RICE LIBRARY BUILDING COMMITTEE

Rice Public Library Monthly Report

Prime Contract Potential Change Order #009 : Historic Shelving Relocation

Prime Contract Potential Change Order #014 : ASI #2 Community Room Ceiling Changes

4 Mezzanine Section 2
1/2" = 1'-0"

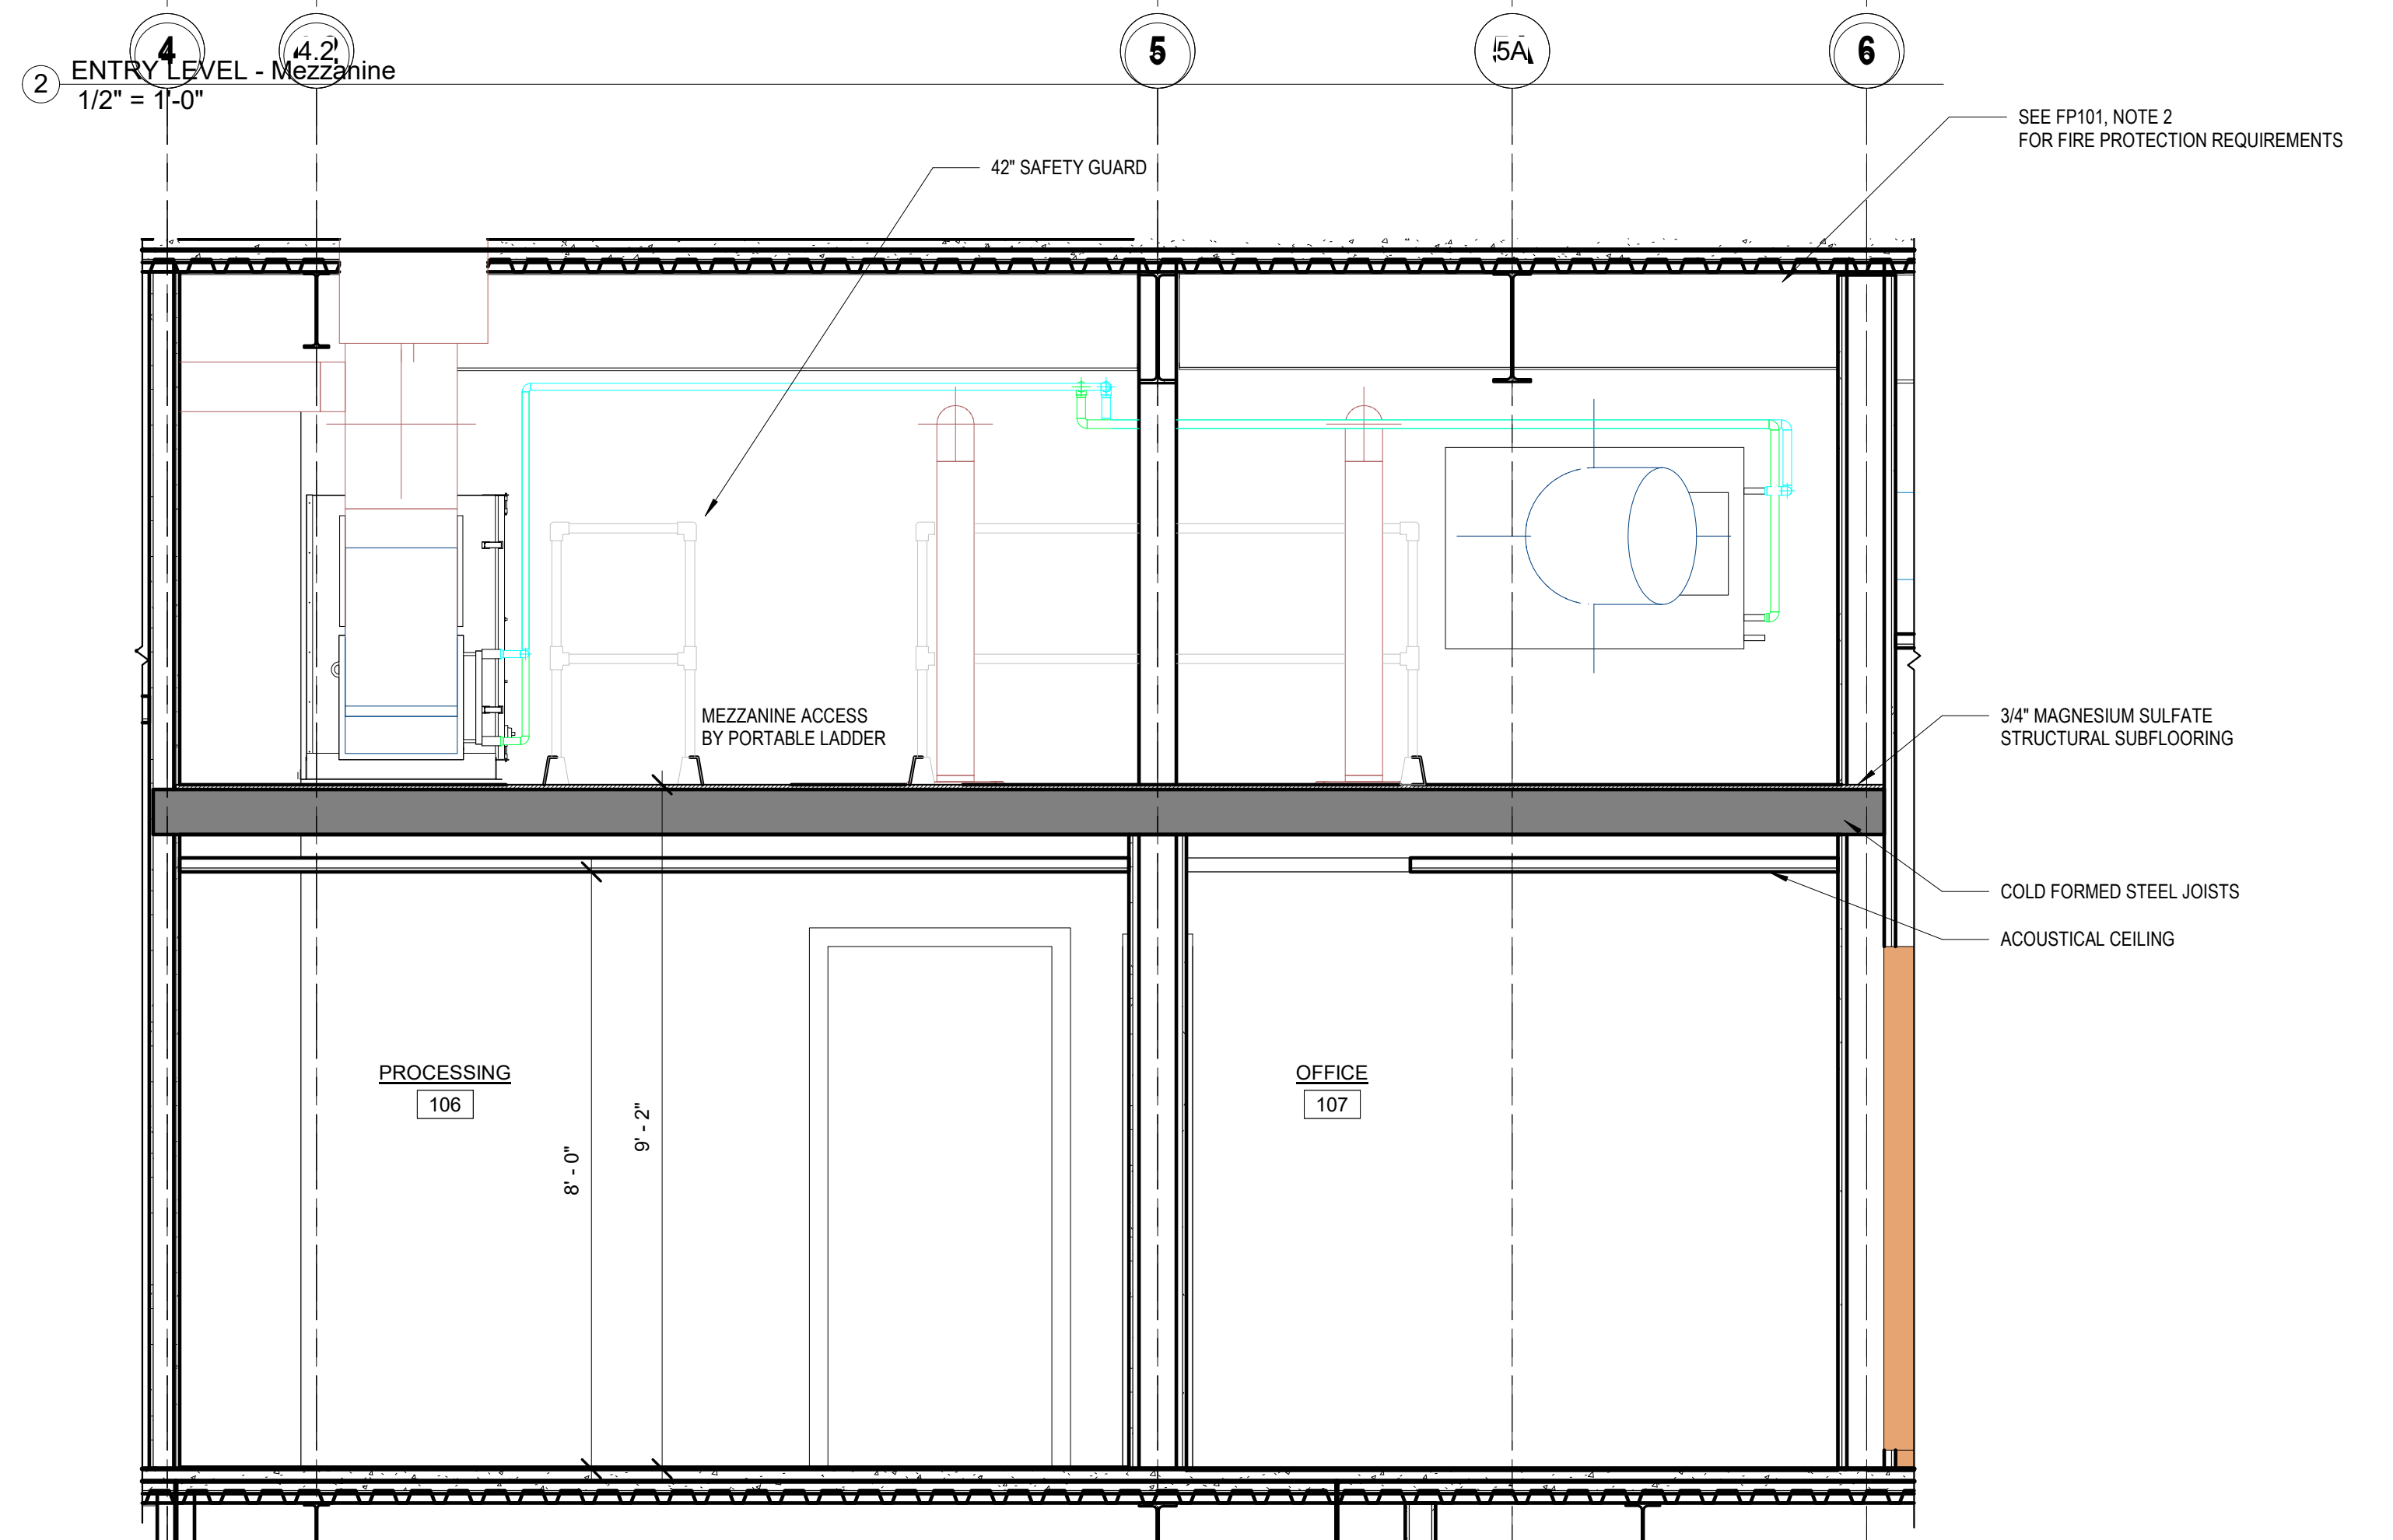
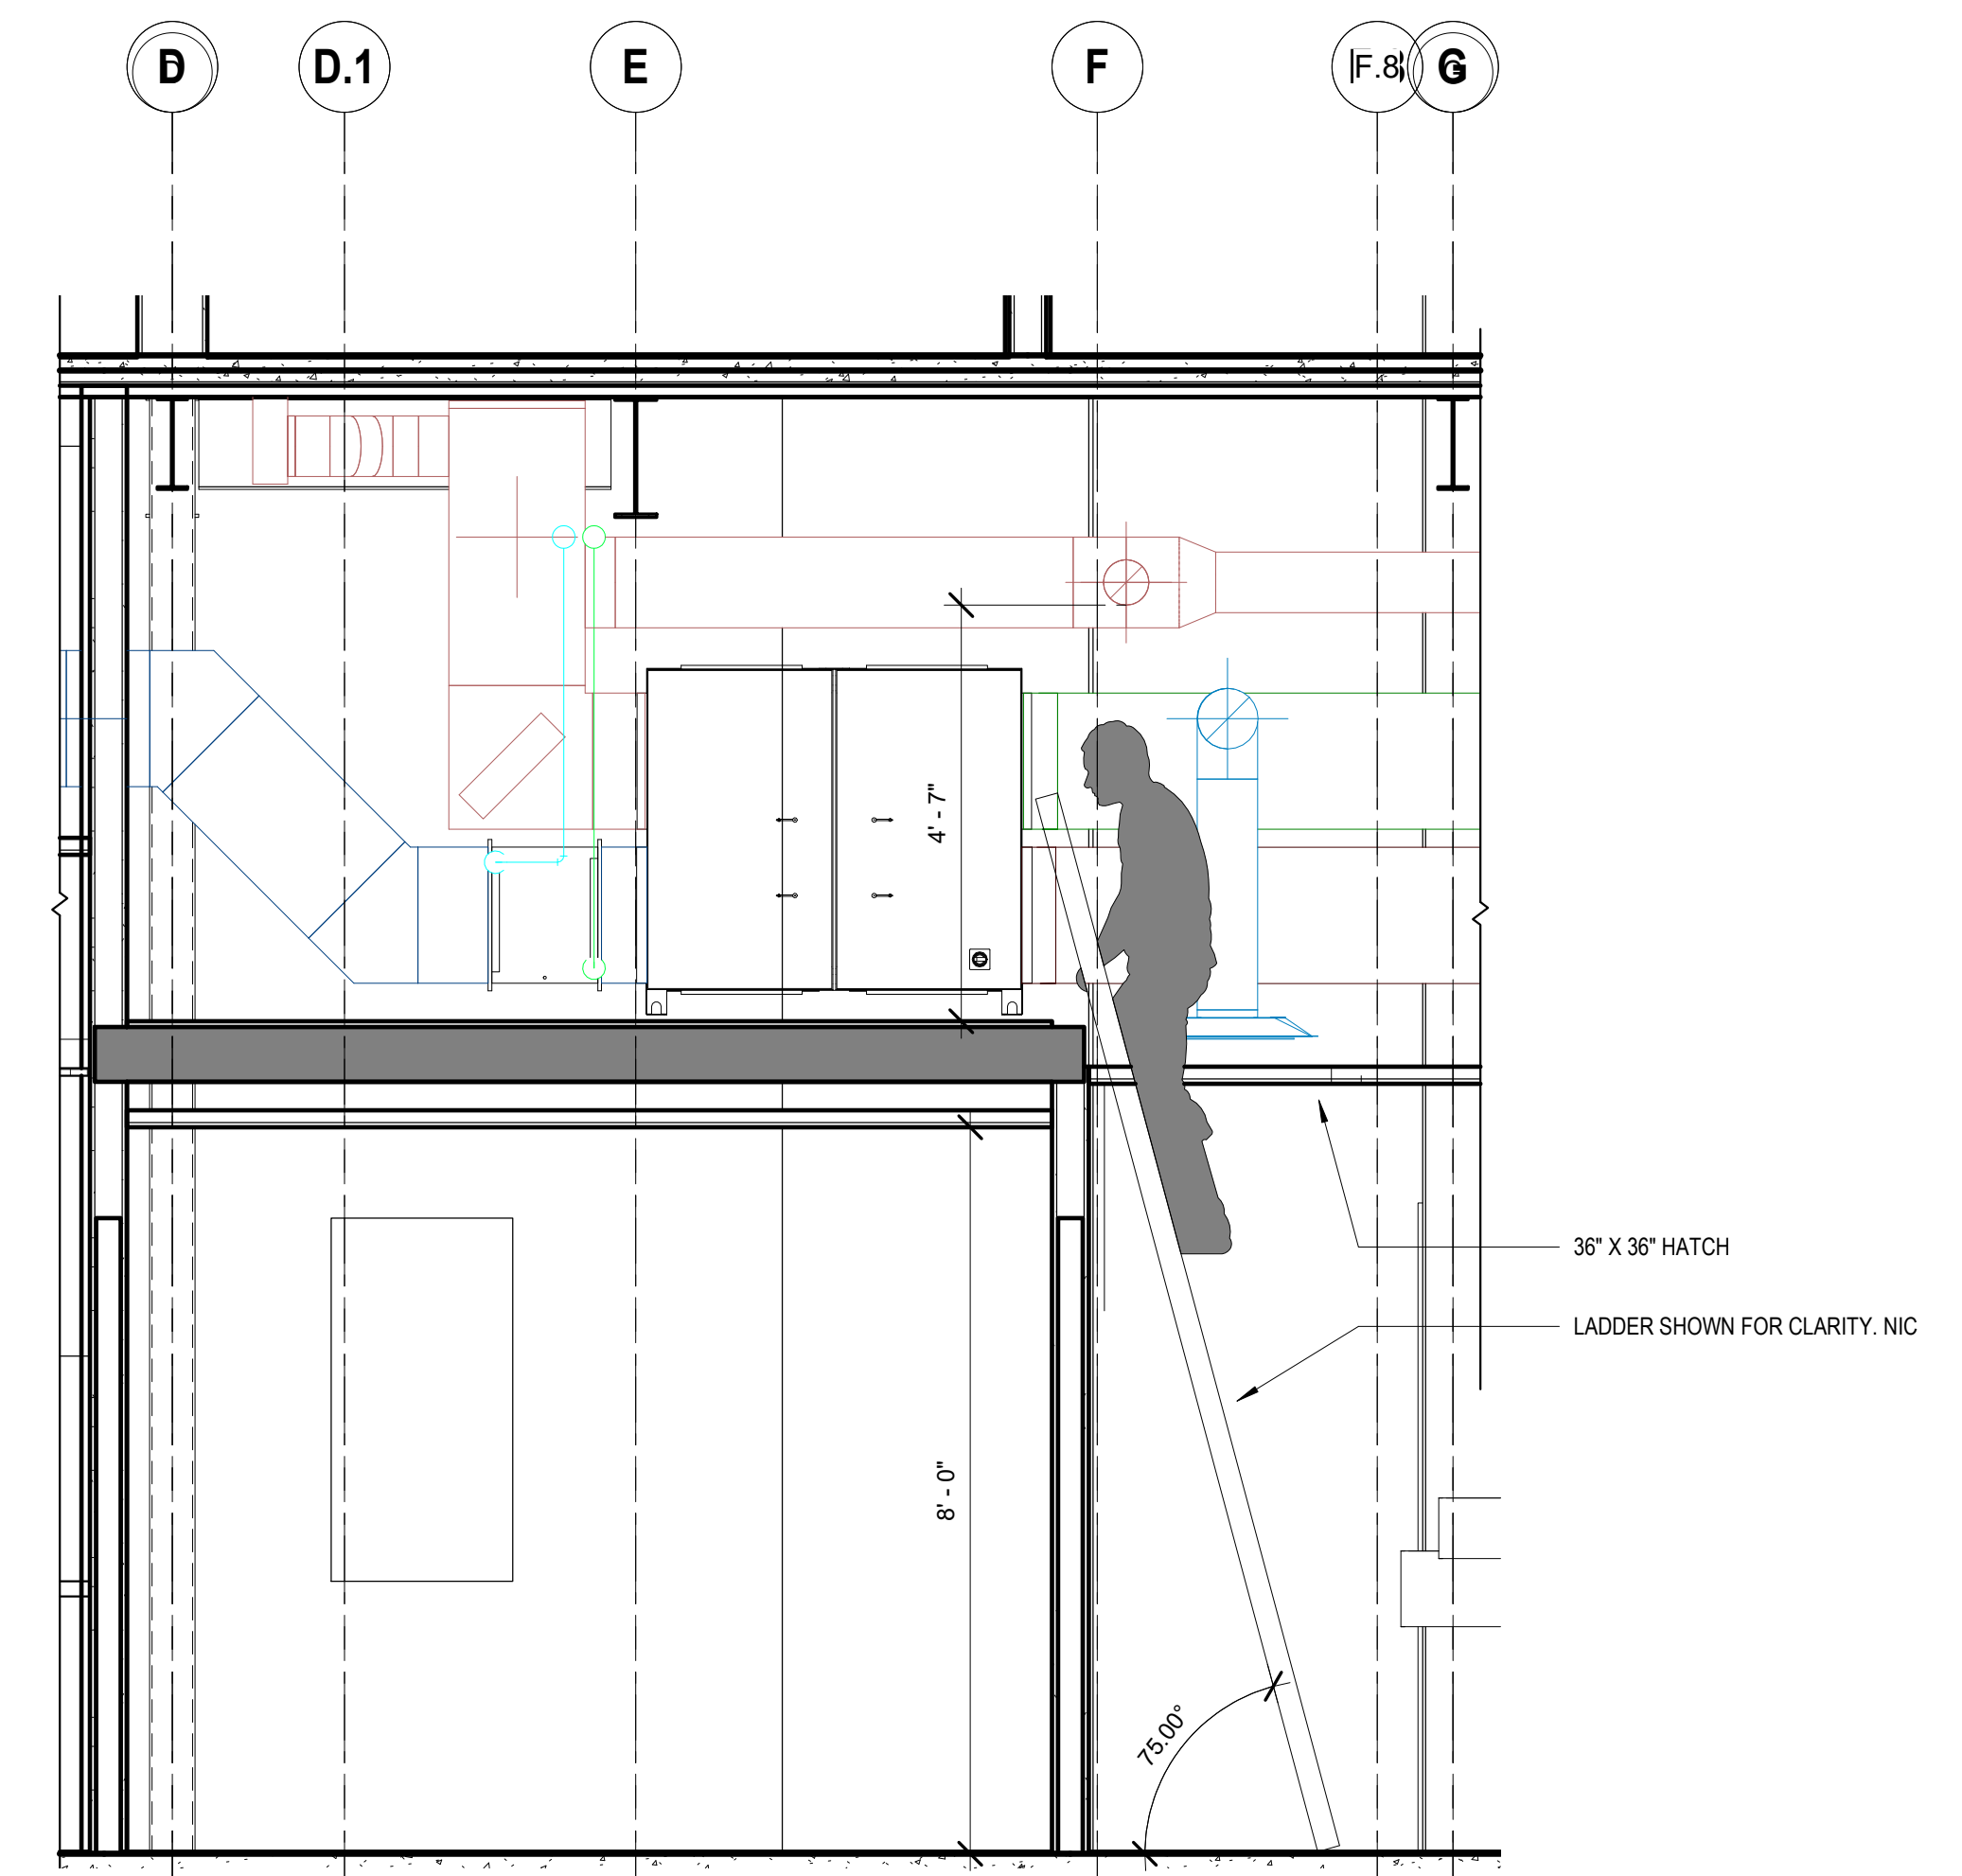
The following is a lump sum PCO for the framing and electrical work at the new equipment platform that was shown in Lassel's sketch sent to Wright Ryan on 2/25/2021(See attached). The price includes the following:

1. Metal joists Framing, fire rated plywood floor and access hatch
2. New outlet and strip light fixture (Furnished and Installed)

Please note that this does not include sprinkler because we do not have the design submitted yet so we don't know what to price. It also doesn't include any soffit or ceiling modifications below the platform. If Wright Ryan receives further detail we can provide further pricing.
